Lake Fordyce Dam Seepage Mitigation Project (Lake Fordyce, Nevada County)

**ADDENDUM to the
Initial Study and Mitigated Negative Declaration and
Previous Addendum for the Lake Fordyce Dam
Seepage Mitigation Project**

SCH No. 2020090506

May 2024

Figure 2-1. Work Area Components

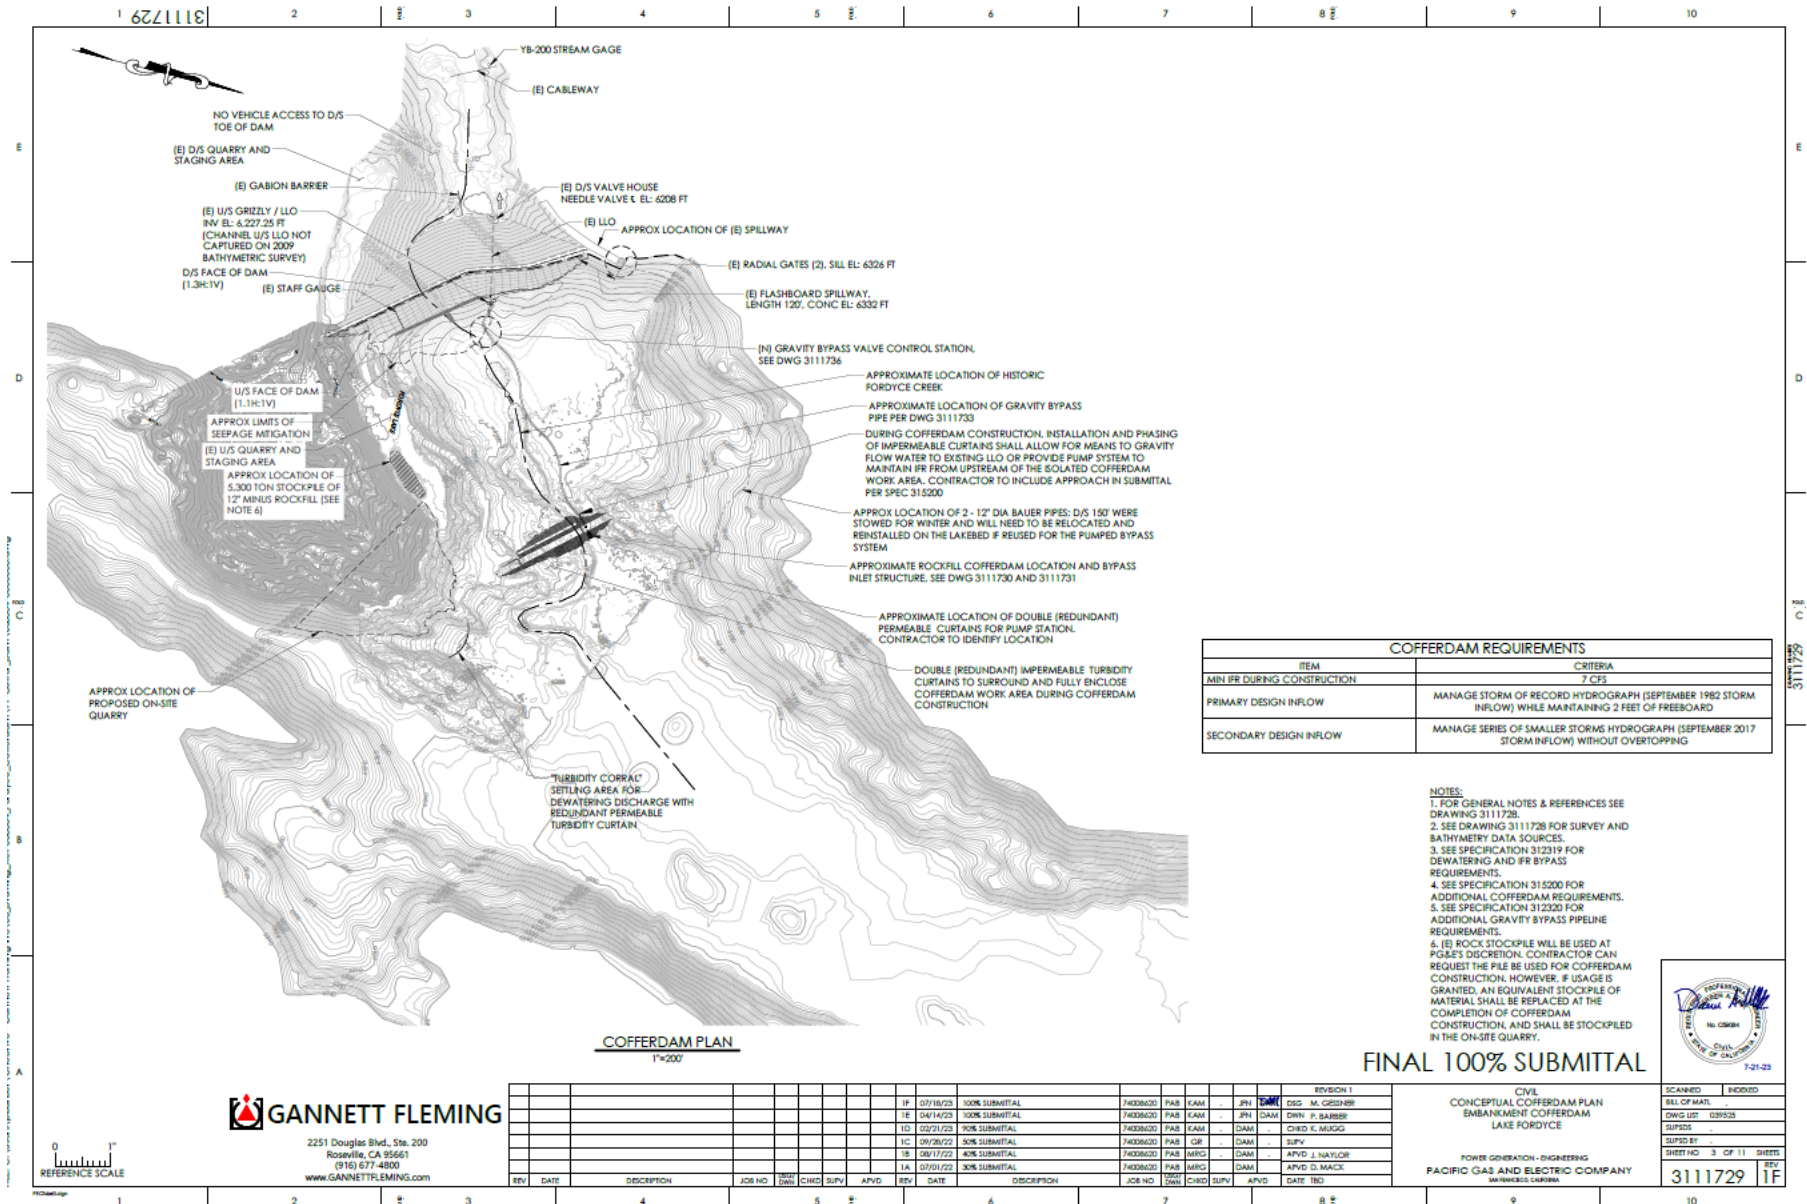
On-Site Rock Quarrying: One or two local quarry areas would be developed to source rock for the cofferdam embankment and associated rock buttress. This includes a preferred quarry area and alternate quarry area (Figure 2-). The preferred quarry area is near the abandoned upstream quarry, which was used to source rock for Lake Fordyce Dam. If the preferred upstream quarry area cannot produce enough of the main embankment material, or the larger buttress rockfill, then the alternate quarry area near the existing downstream quarry would be developed. Compared to the alternate quarry location, the preferred quarry location is farther from the dam, reducing the potential risk of damage to the dam from blasting operations; and is closer to the cofferdam location, reducing on-site hauling distance and time.

Modified Project Area: Figure 2- depicts the Proposed Project Area in the vicinity of the dam. The addition of the quarry locations has increased the total Proposed Project Area by approximately 2.3 acres. The change in cofferdam design is contained in the original Lake Fordyce Dam Seepage Mitigation Project Area described in the 2020 IS/MND and 2021 Addendum. The Proposed Project Area along the access road is unchanged by the proposed modifications.

Figure 2-2. Modified Cofferdam Details

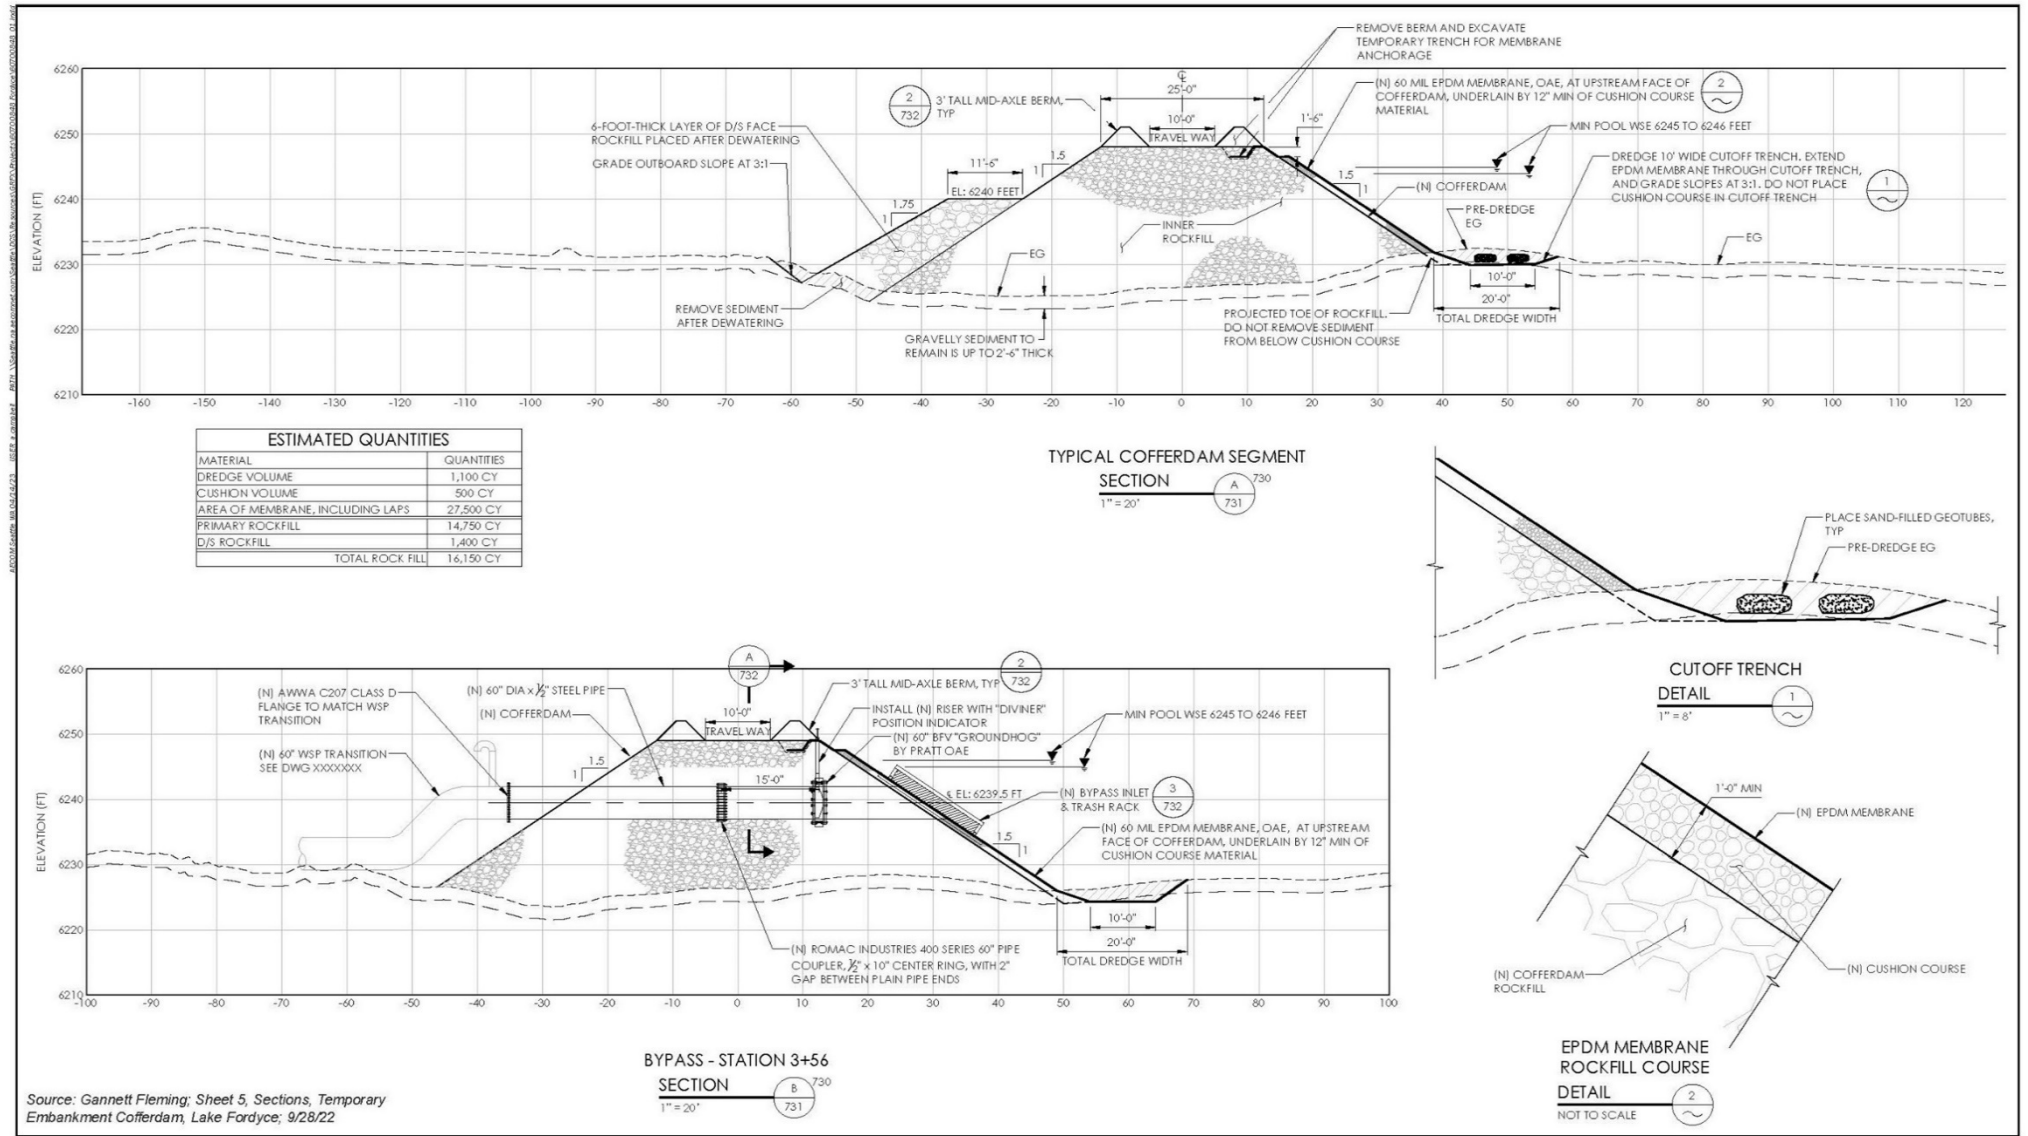
Cofferdam: The Proposed Project would no longer use a bin-wall cofferdam, as previously proposed in the 2020 IS/MND (as carried forward and modified in the 2021 Addendum to include additional dredging and associated changes), and instead would use a trapezoidal rockfill cofferdam in the same location and along the same alignment as the previous bin-wall cofferdam with a slightly larger bottom footprint (Figure 2- and Figure 2-2). The rockfill cofferdam would be approximately 25 feet wide at the crest (the same as the previous bin-wall design), 23 feet tall, and span an approximate length of 450 feet across the reservoir. The bottom footprint of the proposed rockfill cofferdam would be approximately one acre, approximately 0.47 acre larger than the prior bin-wall cofferdam design, due to the trapezoidal shape of the rockfill cofferdam (see Table 2-12).

The upstream face of the cofferdam would be covered with a membrane liner to limit leakage through the cofferdam. The membrane would be placed on the surface of the lakebed and held in place by crushed rock or other aggregate ballast, sand tubes, or rock filled sacks. Installation of the membrane would require dredging for a cutoff trench in the area immediately upstream of the cofferdam. The cutoff trench would have an approximate width of 20 feet and extend along the full length of the cofferdam, approximately 450 feet. Mechanical dredging and/or limited hydraulic suction dredging would be used to remove an additional 1,100 cubic yards of mud, silt, sand, and gravel for the cutoff trench.

pool. The main section of the proposed rockfill cofferdam would require approximately 15,500 cubic yards of material. In addition, a downstream rock buttress would be installed, which would require approximately 1,500 cubic yards of larger rock material. In total, the rockfill cofferdam and its associated buttress would require approximately 17,000 cubic yards of material.

Figure 3-3. Previously Assessed Project Area, Cultural Sites, and New Quarry Areas

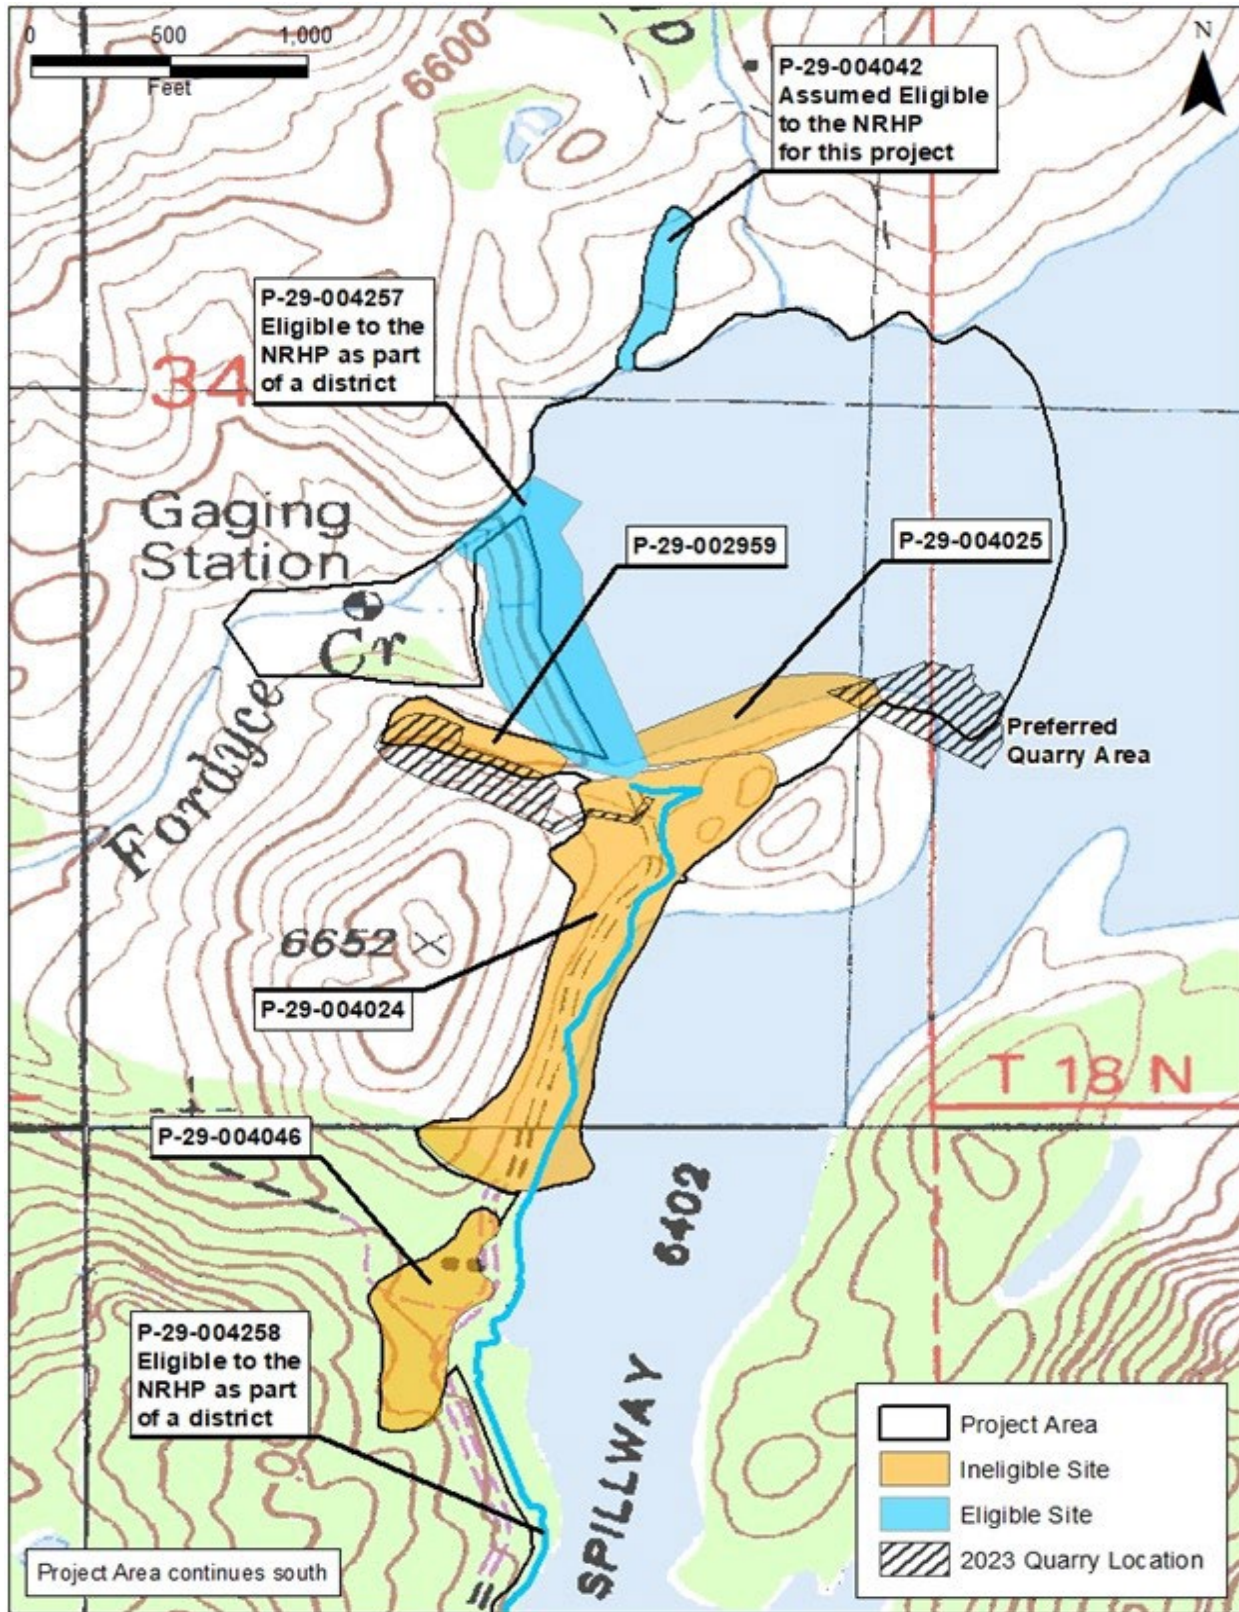
The eastern segment of the preferred quarry area and southern segment of the alternate quarry area are just outside the study area evaluated in the 2020 IS/MND, as shown in Figure 3-3. The portion of the preferred quarry area that was not submerged by Lake Fordyce was surveyed in 2011, and no cultural resources were identified (Information Center Study No. 10561). The northern portion of the alternate quarry area was surveyed for cultural resources in 2011, by Study No. 10561, and in 2020, as part of the original Lake Fordyce Dam Seepage Mitigation Project; no cultural resources were identified. Although the Proposed Project includes additional quarry areas outside of the study area considered in the 2020 IS/MND and 2021 Addendum, the absence of recorded cultural resources in the newly added areas and the non-depositional, steep terrain, and results from neighboring investigations indicate that there is a low probability of encountering cultural resources in these areas.

Sites eligible or assumed eligible for NRHP listing within the original Lake Fordyce Dam Seepage Mitigation Project and Proposed Project Area are also depicted in Figure 3-3 and were considered in the 2020 IS/MND. The 2020 IS/MND determined that the original Lake Fordyce Dam Seepage Mitigation Project would result in no adverse impact to eligible sites P-29-004257 (Lake Fordyce Dam) and P-29-004258 (Lake Fordyce Road), and less than significant impacts to assumed eligible site P-29-004042 (Abandoned Road Grade, Mining Features, and Refuse) with implementation of MM CUL-1. Similar to the original Lake Fordyce Dam Seepage Mitigation Project and analysis in the 2020 IS/MND, the Proposed Project would result in functional improvements to Lake Fordyce Dam and Lake Fordyce Road and would not adversely affect these sites. The Proposed Project would not affect P-29-004042 (Abandoned Road Grade, Mining Features, and Refuse), which occurs outside of the modified cofferdam design area. Additionally, MM CUL-1 (Procedures to Avoid Impacts on Archeological Resources) remains applicable and required.
